RECORD OF DECISION

Harbor at Hastings
Operable Unit Number 02: Hudson River Sediments
State Superfund Project
Hastings-on-Hudson, Westchester County
Site No. 360022
March 2012

Prepared by
Division of Environmental Remediation
New York State Department of Environmental Conservation

FIGURE 2

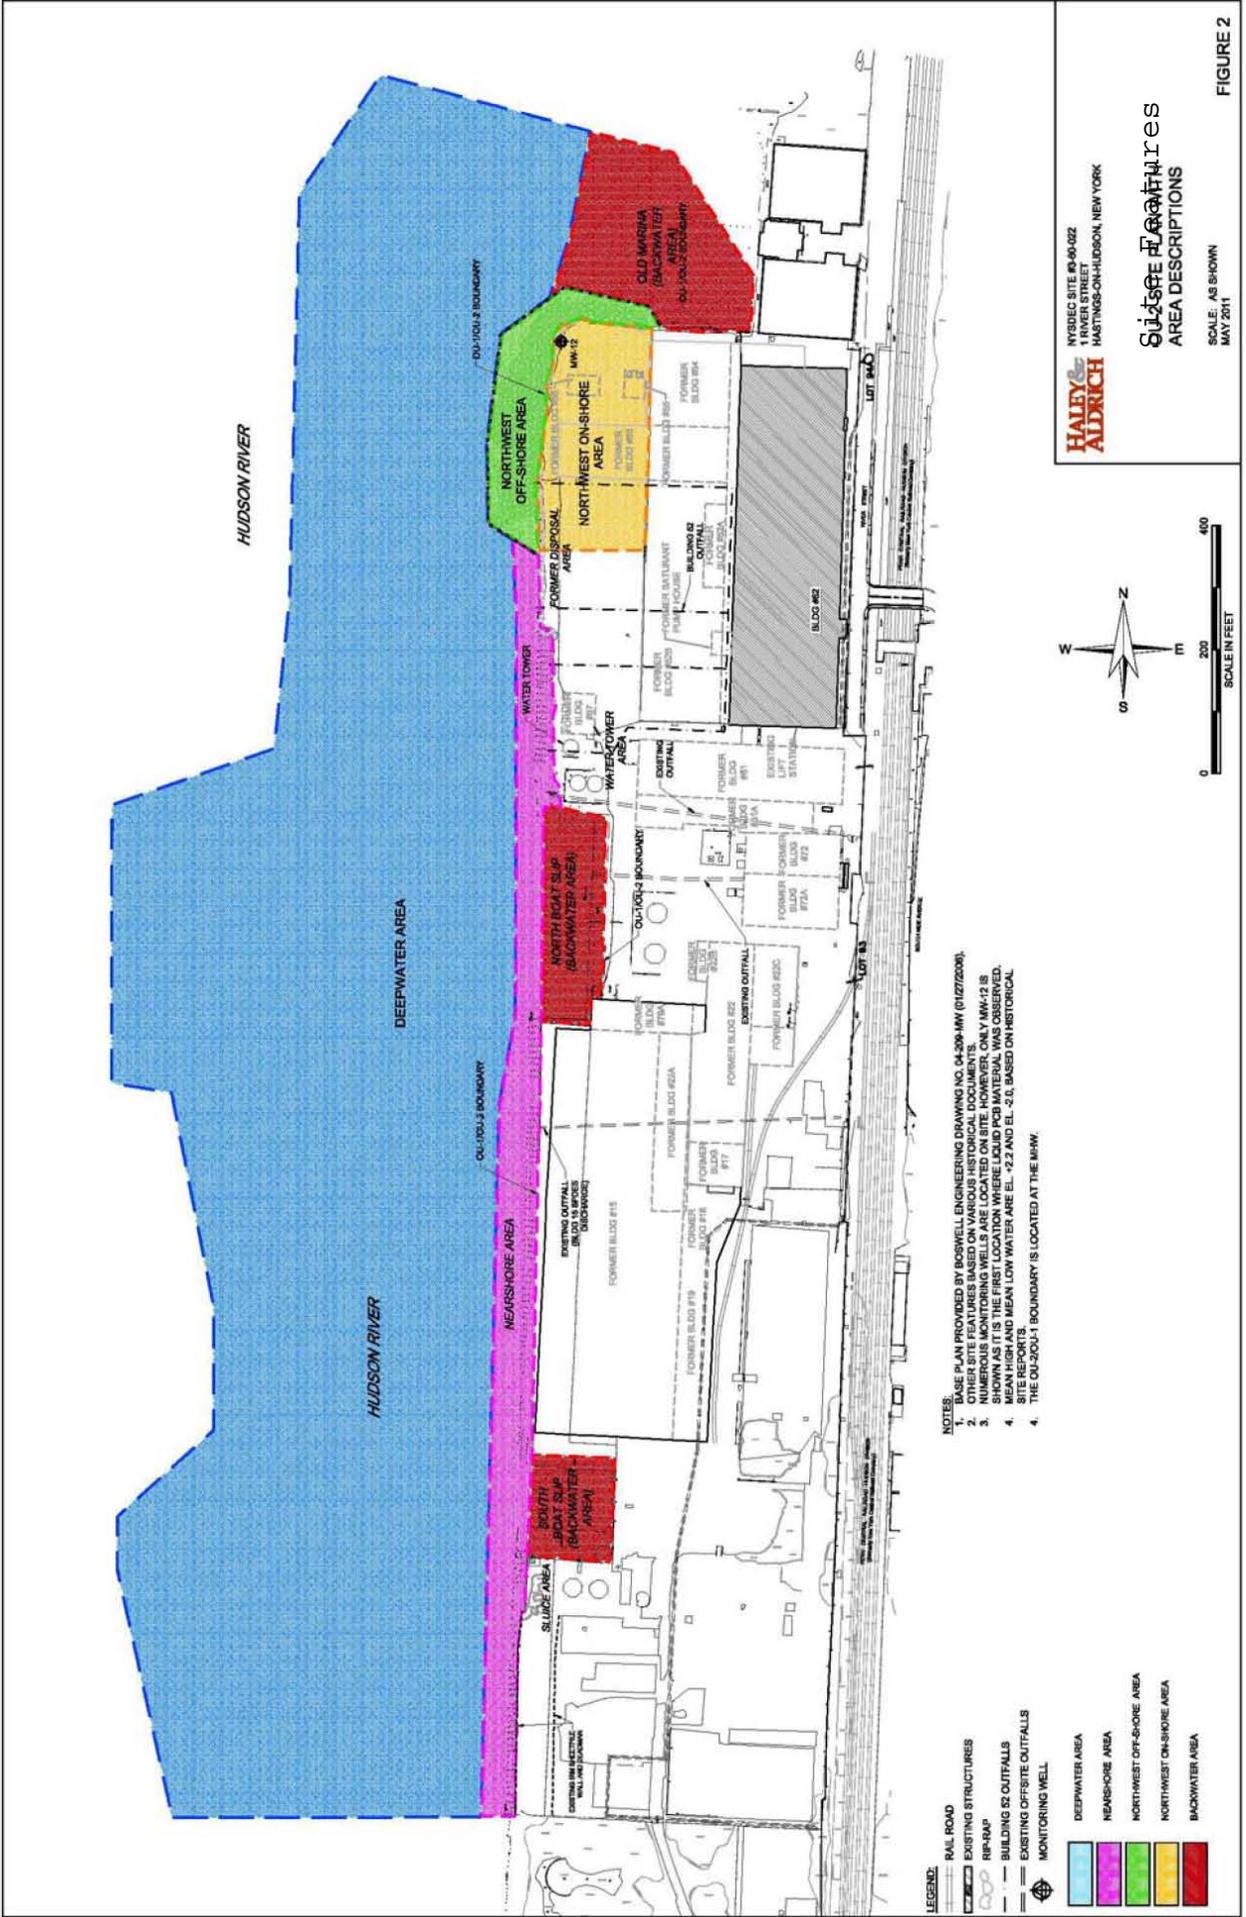
COMMENT 124: Figure 2. An updated version of Figure 2 that has been updated for the new data and uses the nomenclature in the text of the proposed modification is attached.

FIGURE 3

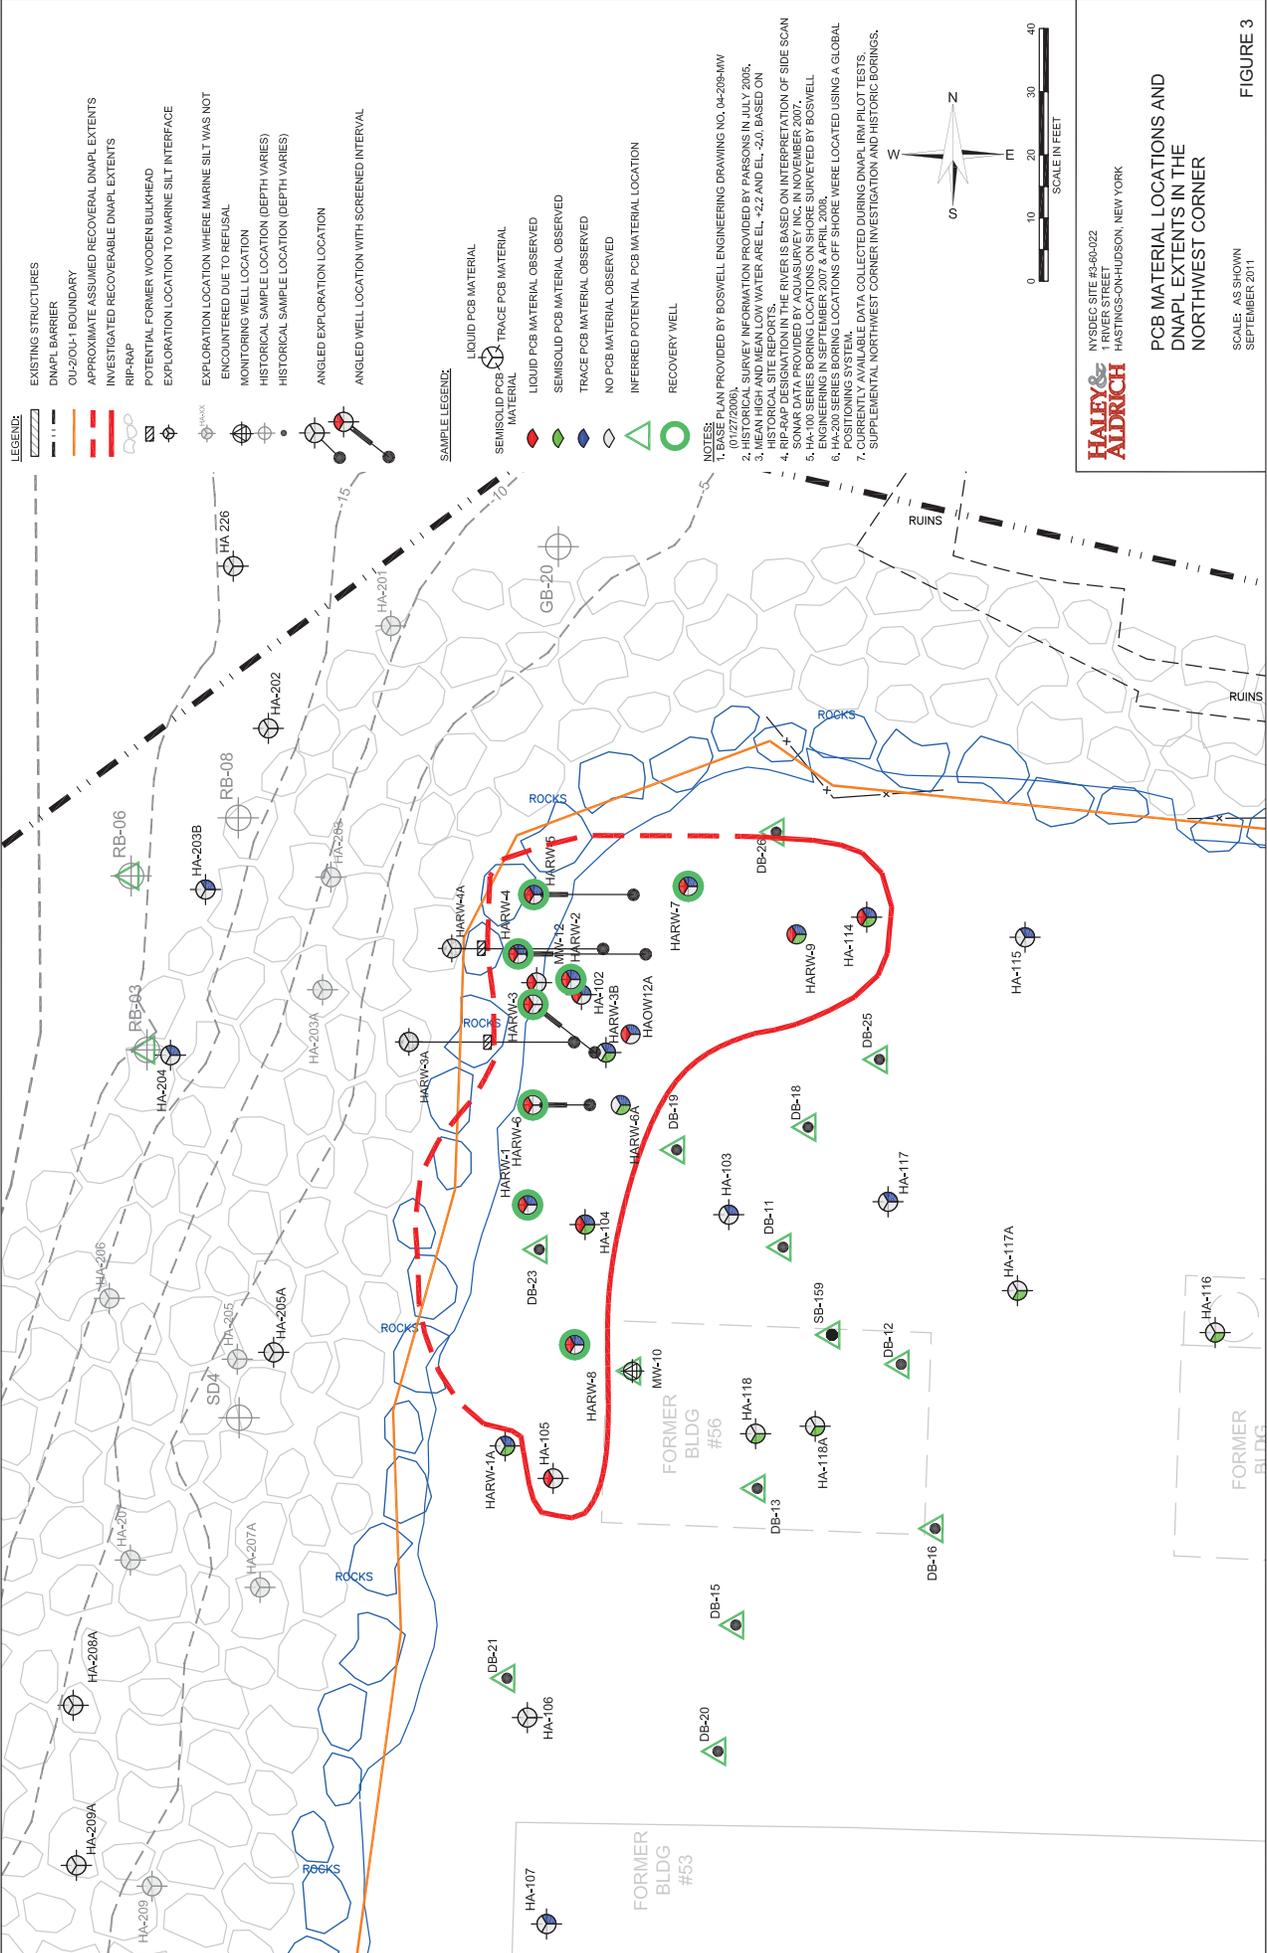
COMMENT 5: How much semi-solid PCBs are present beneath the river?

RESPONSE 5: The presence of semi-solid PCB has been identified in the areas shown on Figure 3 of the ROD. The full extent and amount of semi-solid PCBs present beneath the river has been difficult to estimate due to the difficulty in installing borings and sampling the area immediately offshore of the Northwest Corner. This area was not extensively sampled because the equipment needed to penetrate the rip rap could not access areas of shallow water under current conditions.
